ADDENDUM NO. 03

Date: November 11, 2026
RVi Project #: 26000793
Project Name: South Park Phase Two

To: Prospective Bidders
FROM: RVi Planning + Landscape Architecture (RVi)

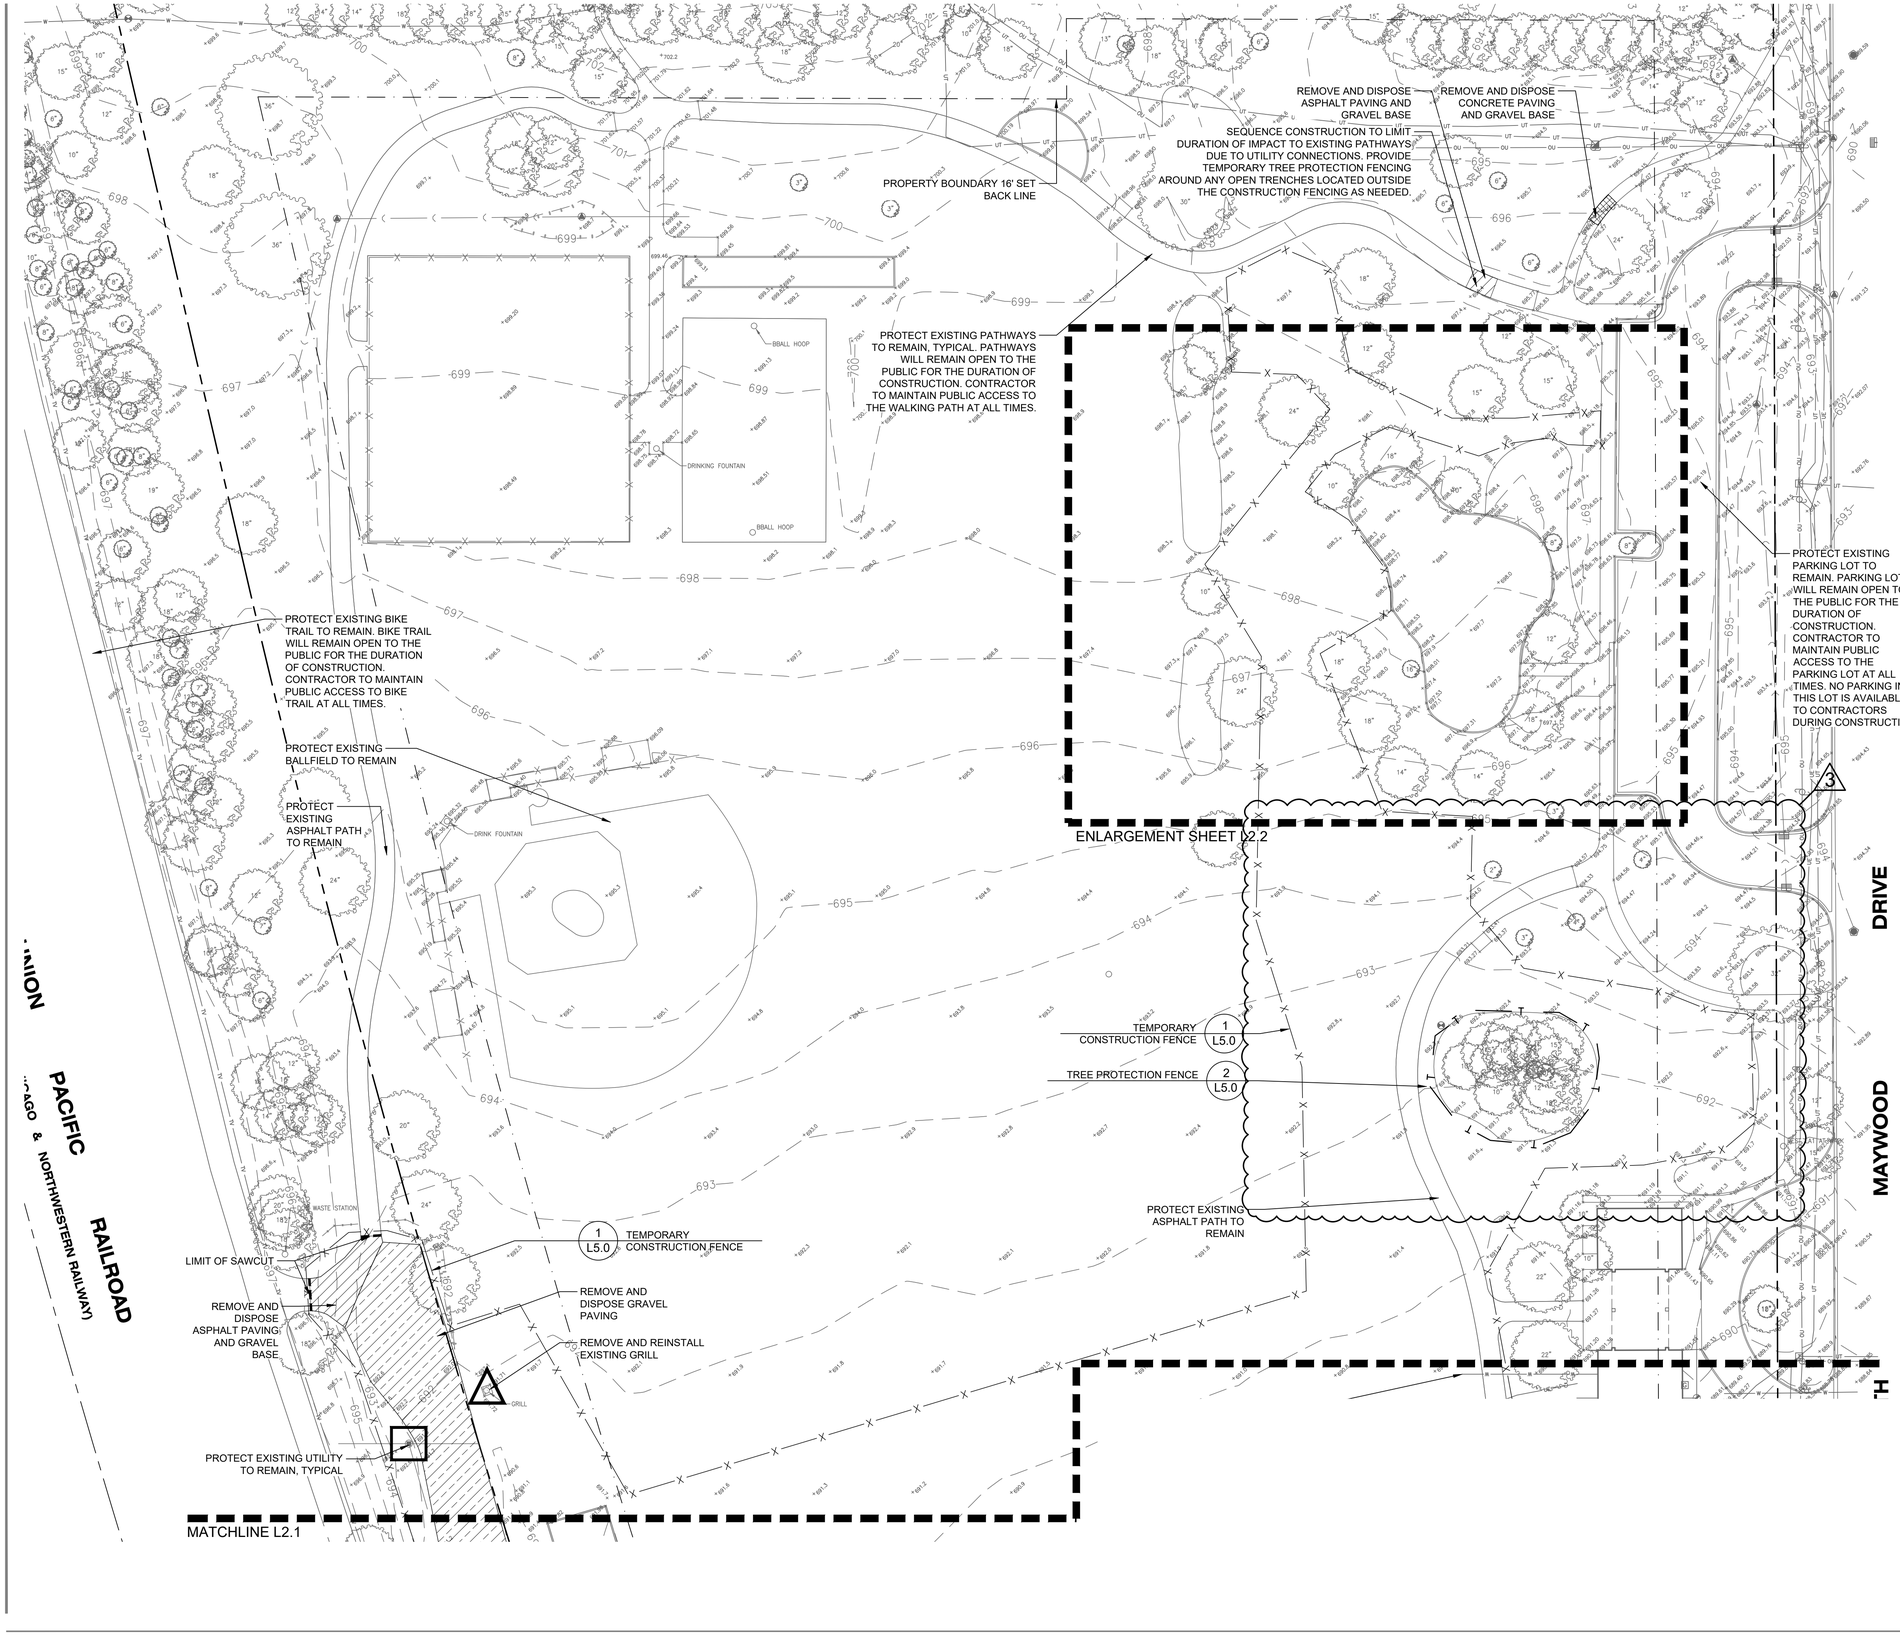
- **L2.0 Site Preparation and Removals Plan – North**
  - Added sequencing note
  - Revise temporary construction fencing layout
  - Revise temporary tree fencing layout

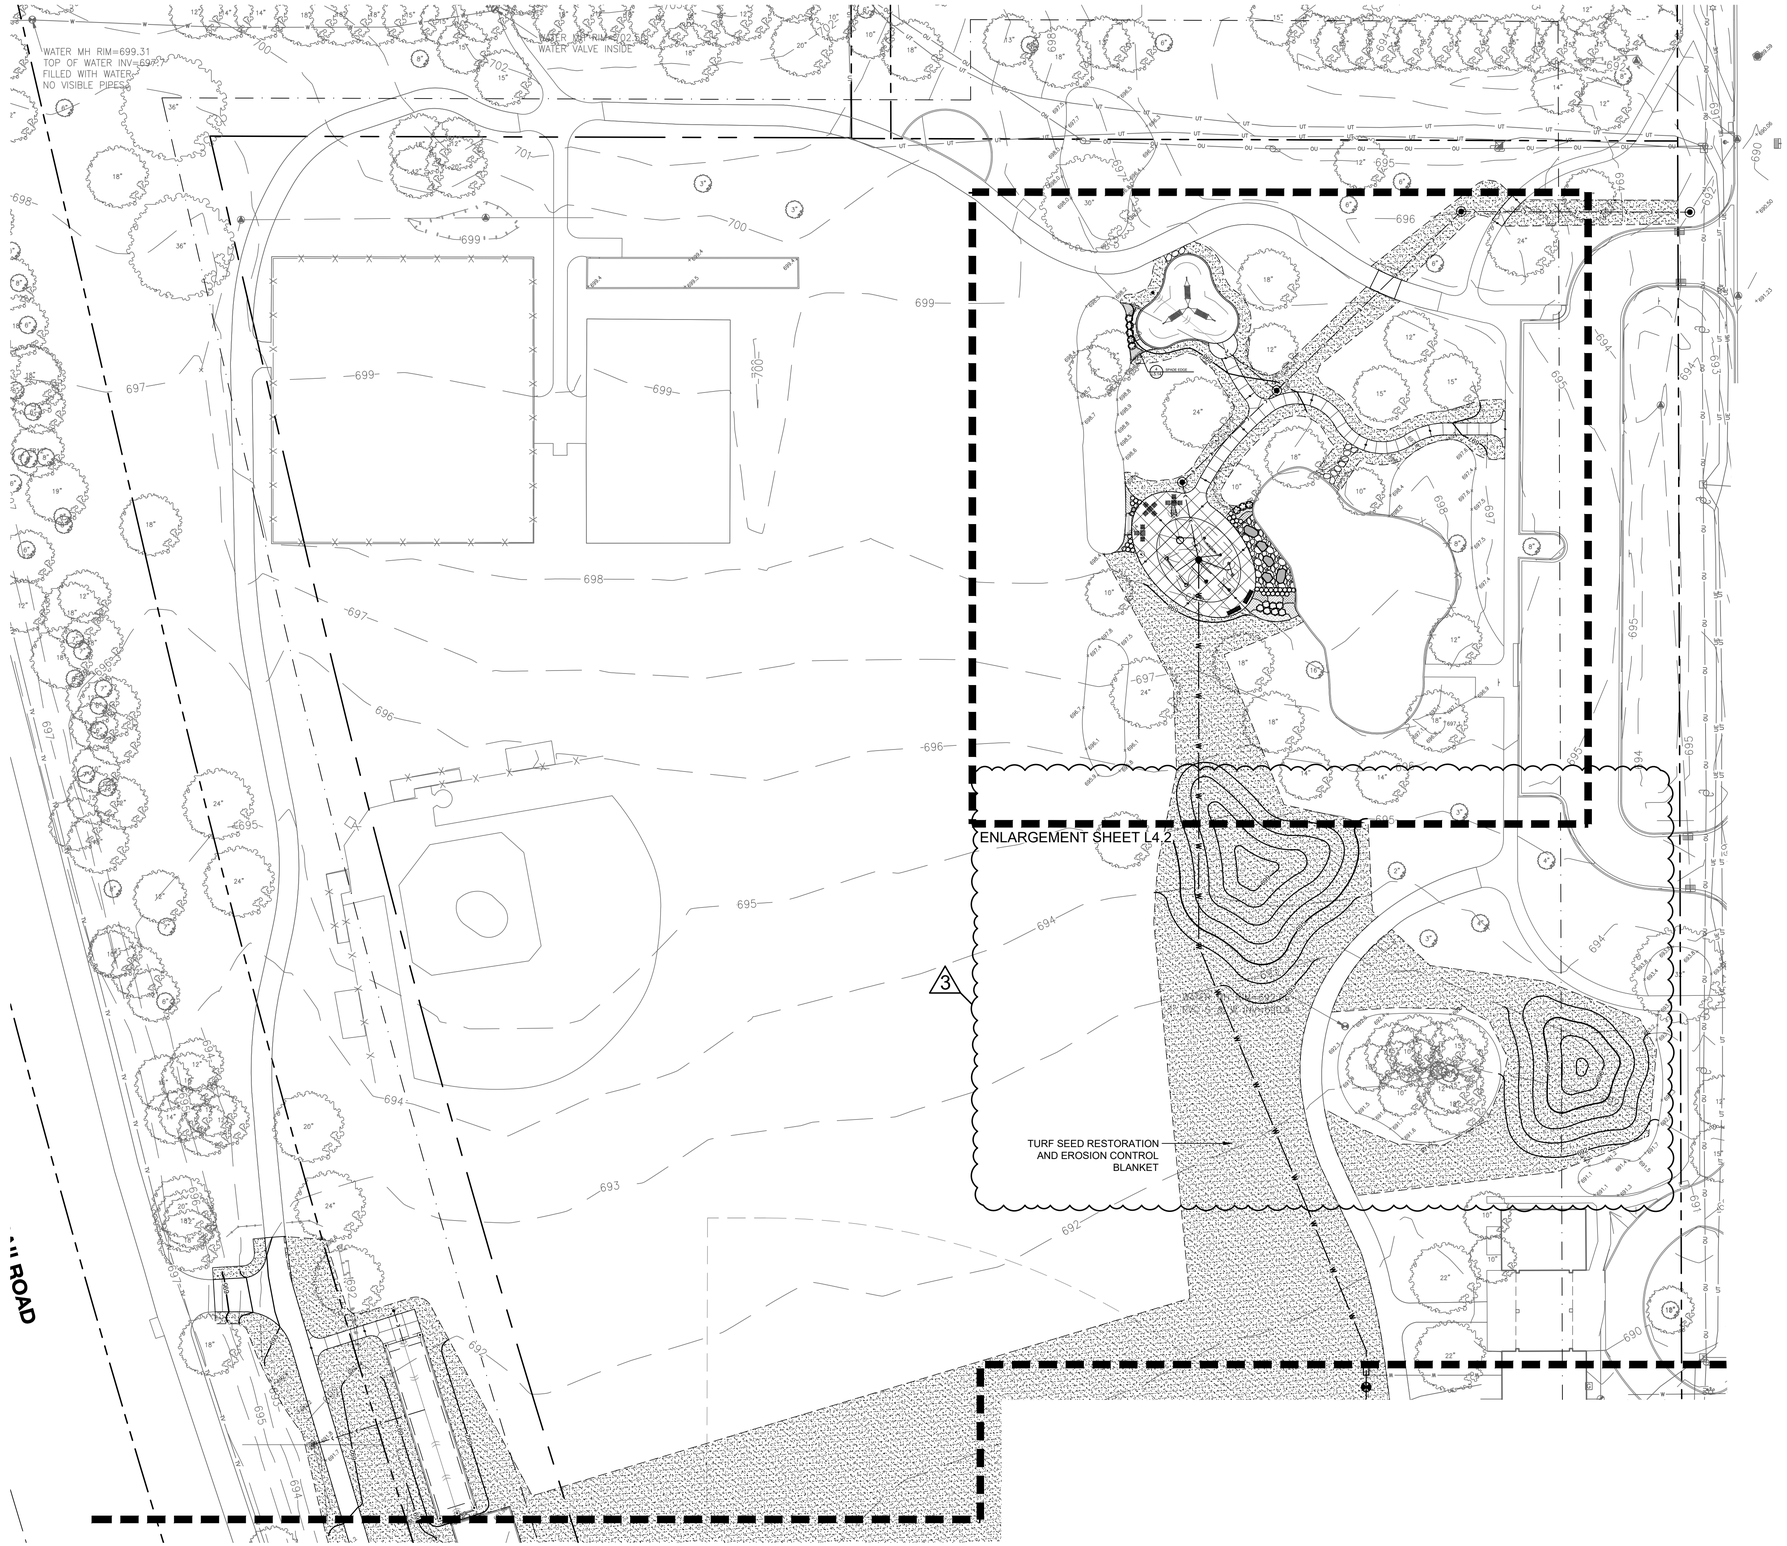
- Detail callout for Outcropping Stone and Asphalt Paving – Pedestrian added
- **L4.0 Planting Plan – North**
  - Revised limits of turf grass seed restoration

5 DEPRESSED CURB

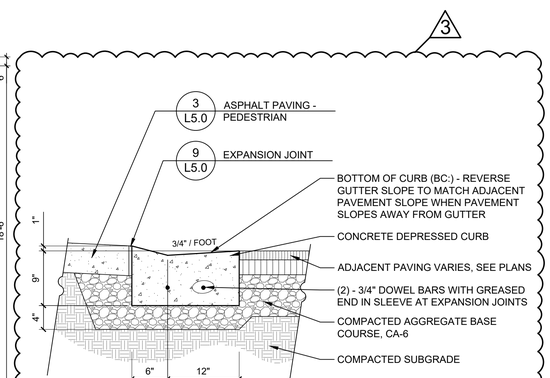
- What infield mix would you like, and can we use the attached?
  Response: See included Infield Mix Specification Section 321823 Athletic Surfacing
- There are 2 different curb and gutter details showing different depths of gutter. The Lake Forest detail indicates a 9-inch gutter depth which is standard while the depressed curb and gutter detail indicates a 12-inch gutter depth. Please confirm the depth of the gutter.

- Revised Detail #5 – Depressed Curb
- **L5.2 Details**
  - Added Detail #8 – Stone Outcropping
- **L5.3 Details**
  - Revised Detail #5 – Backstop
- **L5.4 Details**

Response: The depth of the depressed curb is to be 9 inches. Detail 5/L5.1 has been revised to reflect this.
- I am having trouble figuring out the spacing of the large netting posts while looking at the layout on sheet 5.7. Can you verify?

3 CHAIN LINK FENCE

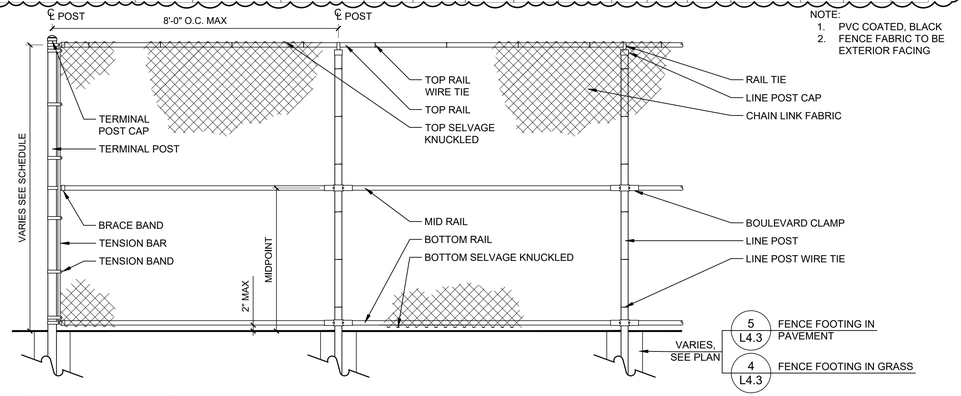
- There are no mention of the size for the line posts of the 10'tall Chain Link Fence. Could you please clarify?
  Response: The line posts for the 10' height chain link fence are to be 2-3/8".

- There is no Fence Schedule for the 10' high fence (Fence Schedule is Blank)
  Response: The fencing schedule has been populated and updated in the detail.

- Revised Detail #3 – Chain Link Fence
    - Populated fence schedule
  - Revised Detail #4 – Chain Link Fence Footing in concrete paving
  - Revised Detail $5 – Fencing / Netting Elevation

5 FENCING / NETTING ELEVATION

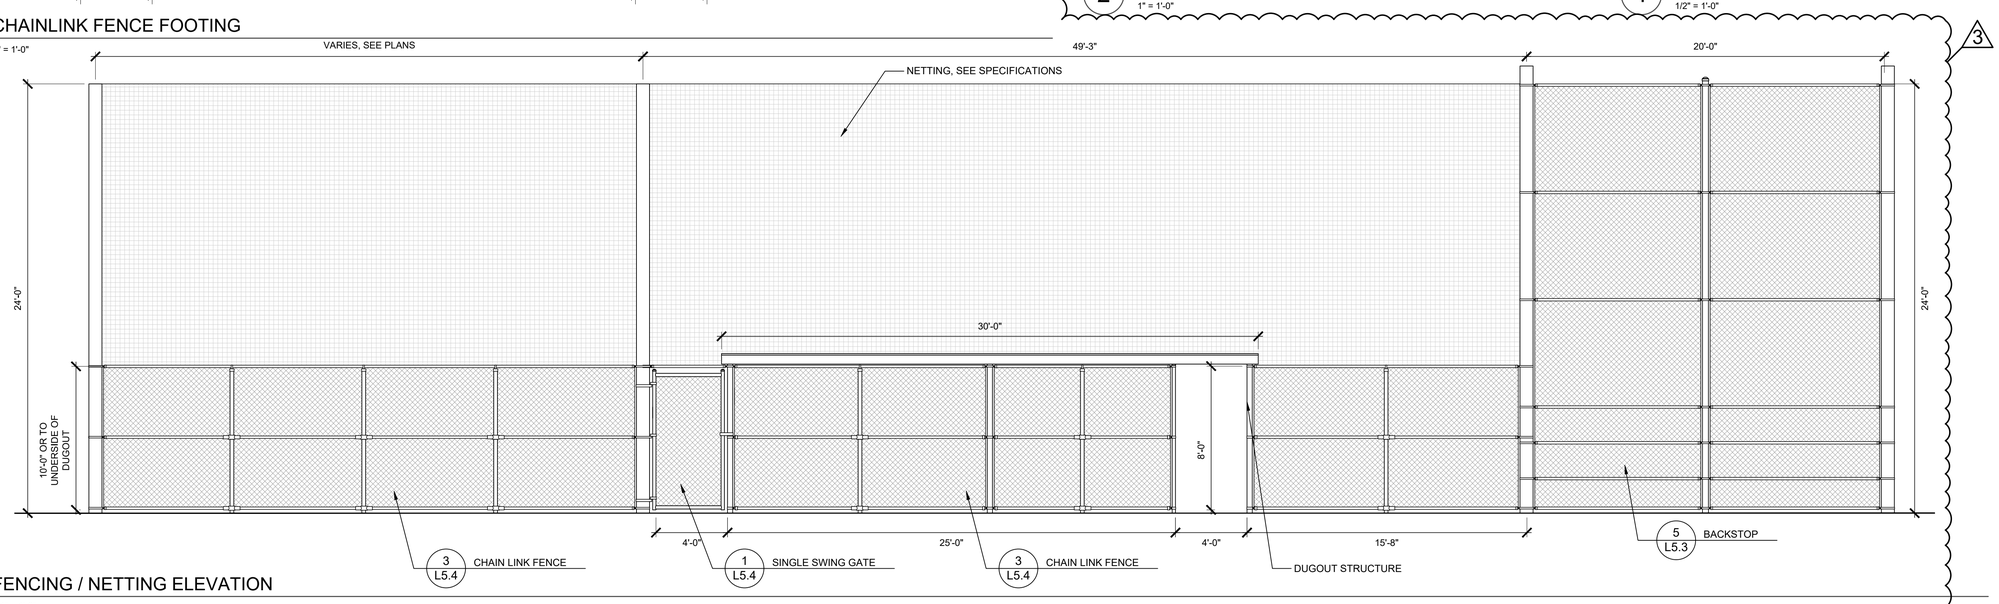
- Are the gates 4' opening (Detail 4) or 5' opening (Detail 5 on sheet L5.4 elevation detail)?
  Response: the gate openings are to be 4' wide.
- Can you give us the diameter of the dugout posts, as our fence appears it will tie into them?

- Revised gate widths to 4’ wide
    - Revised net post spacing

6 BAG TOSS BOARDS

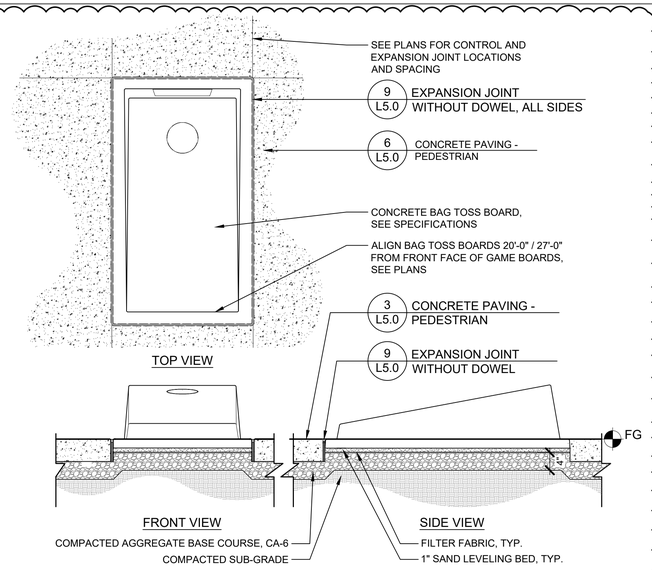
- Revised Detail #6 – Bagg Toss Boards
        - Corrected Concrete Paving – Pedestrian callout
- **L5.6 Details**
    - Revised Detail #1 – Batting Cage Layout

4 BIKE RACK AND REPAIR STATION ENLARGEMENT

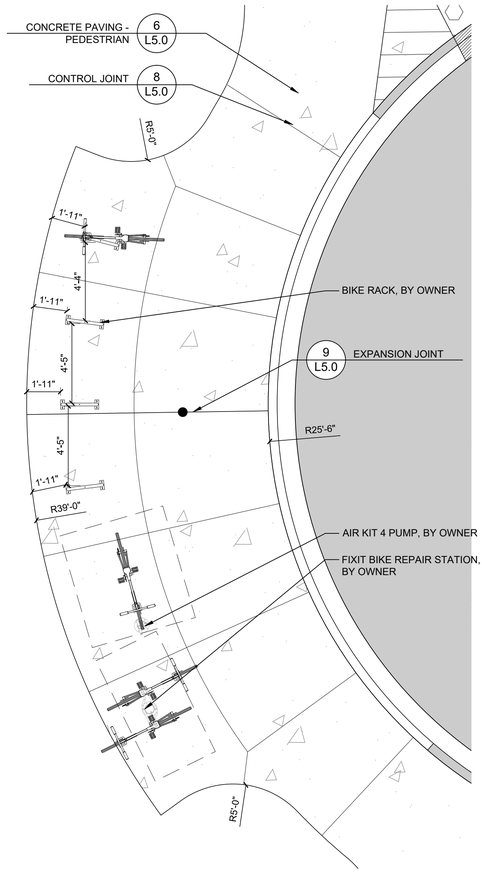
- Revised Detail #3 – Dugout Elevation B
        - Revised labels
    - Revised Detail #4 – Bike Rack and Repair Station Enlargement
        - Noted items supplied by Owner

1 DUGOUT ENLARGEMENT

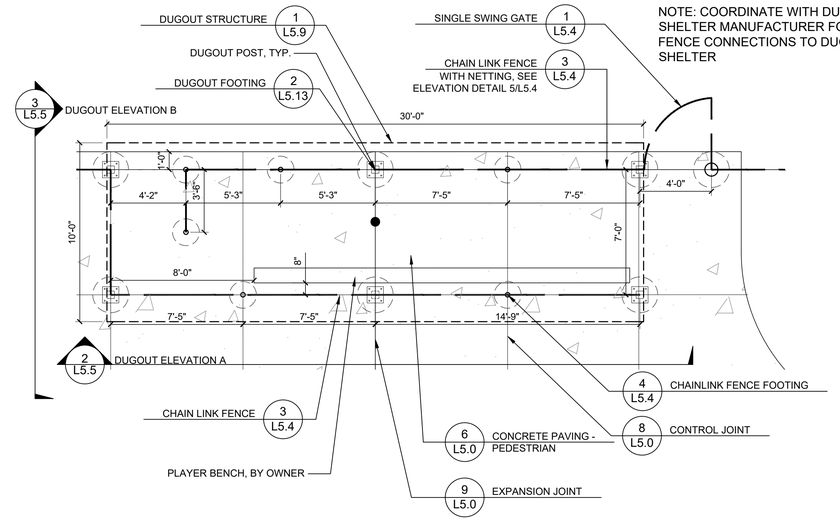
- **L5.5 Details**
    - Revised Detail #1 – Dugout Enlargement
        - Revised Callouts
    - Revised Detail #2 – Dugout Elevation A
        - Revised chain link fence height

4 CONCRETE CURB AT ARTIFICIAL TURF

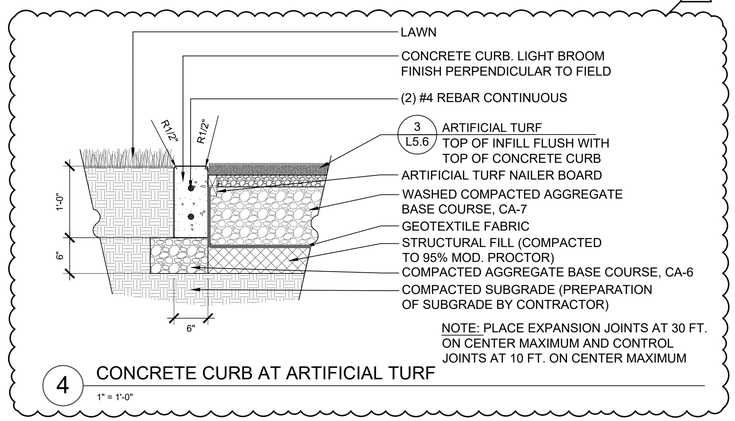
- Corrected Artificial Turf callout
    - Revised Detail #4 – Concrete Curb at Artificial Turf
        - Corrected Artificial Turf callout
- **C1.0 SESC Plan**
